PRELIMINARY DRAINAGE REPORT AND MDDP ADDENDUM
FOR
HOMESTEAD NORTH AT STERLING RANCH PRELIMINARY PLAN

February, 2021
Project No. 25188.00

PCD Filing No.:
SP-20-008

DRAINAGE MAP
HOMESTEAD NORTH
JOB NO. 25188.00
2/15/21
SHEET 1 OF 2

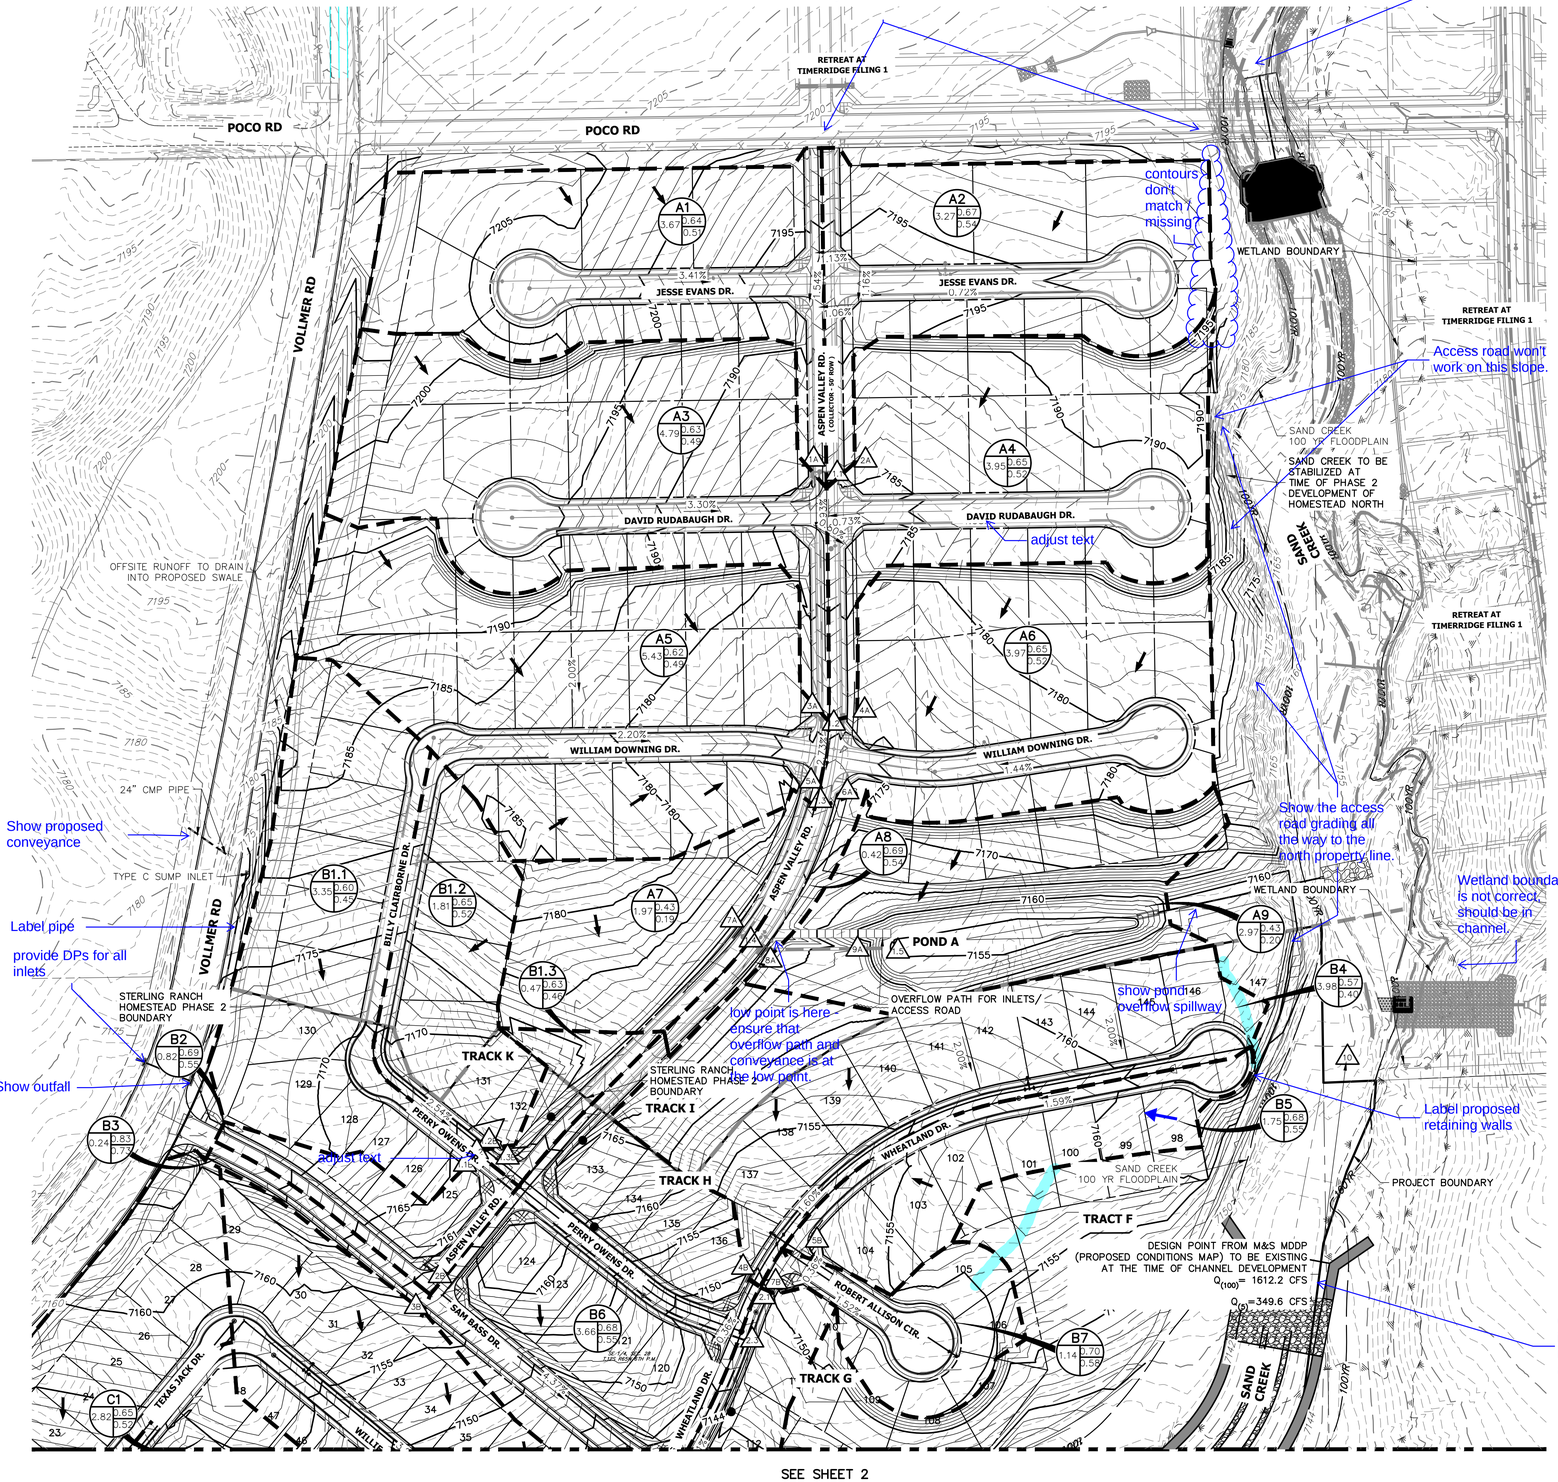
Show proposed contours for Poco Road (under construction) https://epcdevplanreview.com/Public/ProjectDetails/111186

Label channel flows - MDDP/DPBS/FEMA

contours don't match / missing?

Access road won't work on this slope.

Show proposed conveyance

provide DPs for all inlets

Show outfall

show pond overflow spillway

Show the access road grading all the way to the north property line.

Wetland boundary is not correct, should be in channel.
